# Norlite Corporation

SUBJECT: Fugitive Dust Plan Addendum - Comment Resolution

SUBJECT: Norlite Response to NYSDEC Comments on FDP Addendum  
SCI-TECH Project No. 95065

## 8.0 SCHEDULE FOR IMPLEMENTATION

Figure 8-27  
Rear Kiln Seals

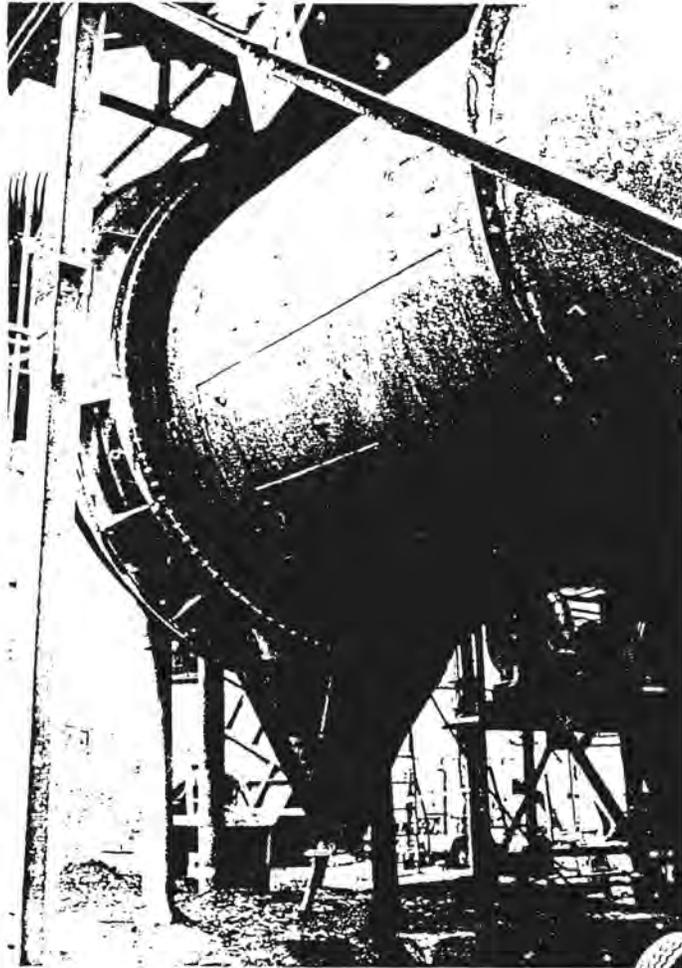
- Kiln Seals: The seals at the rear of each kiln (Fig. 8-2, Item 13) will be maintained during planned kiln shutdowns as needed to prevent emissions from this area (Figs. 8-27 and 8-28). Additionally, as part of the most recent permit modification package, Norlite agreed to install additional controls and procedures to prevent fugitive dust emissions from this source.

The seal mechanism and knock out box will be maintained during all planned shutdowns.
